SITE PROBLEM
REPORT TRANSMITTAL

FILE: 13-5-322
CONTRACT NO: 620-00 05
SPR 322 REV. 1
TITLE LOW PRESS.
LEVEL FOLLOWING
REACTOR TRIP
DATE: 6-25-76

SITE PROBLEM REPORT

TITLE LOW PRESSURIZER LEVEL FOLLOWING REACTOR TRIP

150"

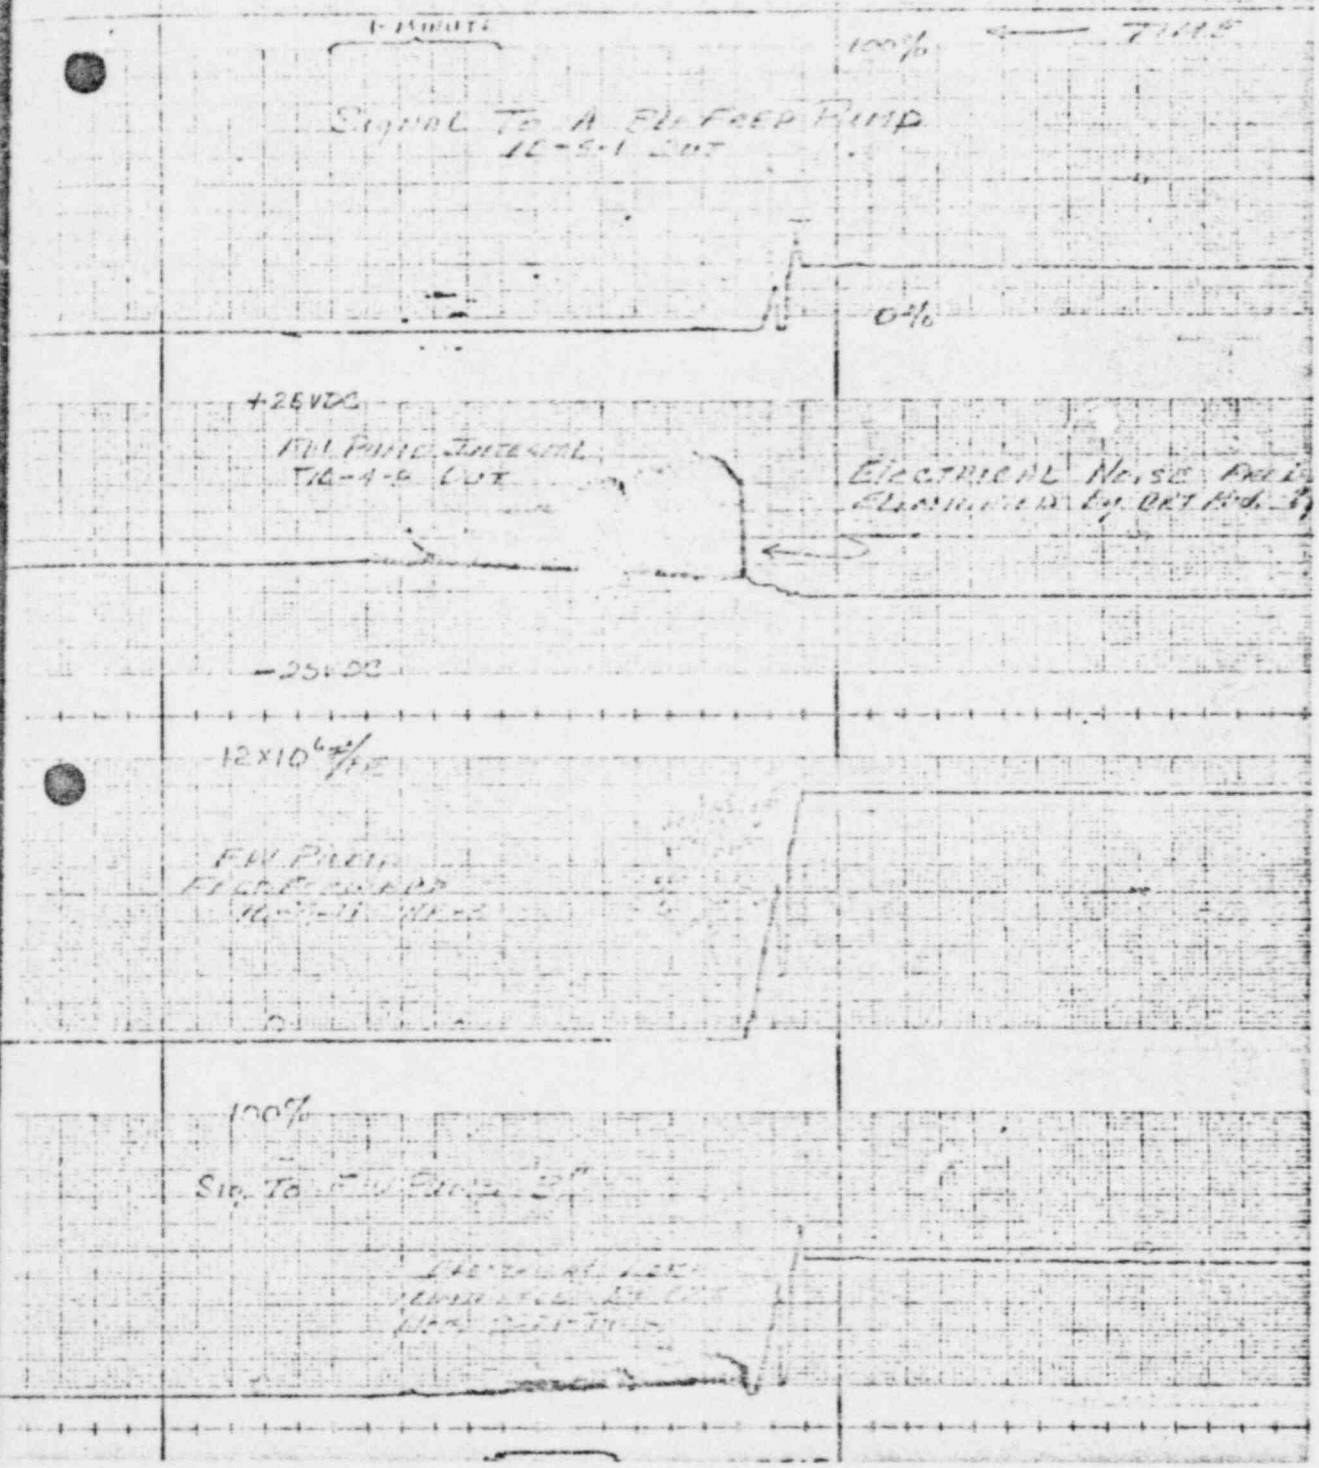
Attached please find charts recorded during a generator trip test conducted 8-13-74 which resulted in a reactor trip. From these charts and table 1 it can be noted that while there was flow through the line there was a pressure drop i.e., SG pressure is 30 psi higher than THP, immediately after the trip with no pressure drop due to flow the pressures equalized. For the next 3.5 min. the SG pressure is less than THP. Also note the waves in the SG pressure recorded during the first minute are not present in the THP pressure. These conditions seem to be a good indication that the check valves did close.

Investigation
should be
conducted
w/

20%
Should not
come back
up
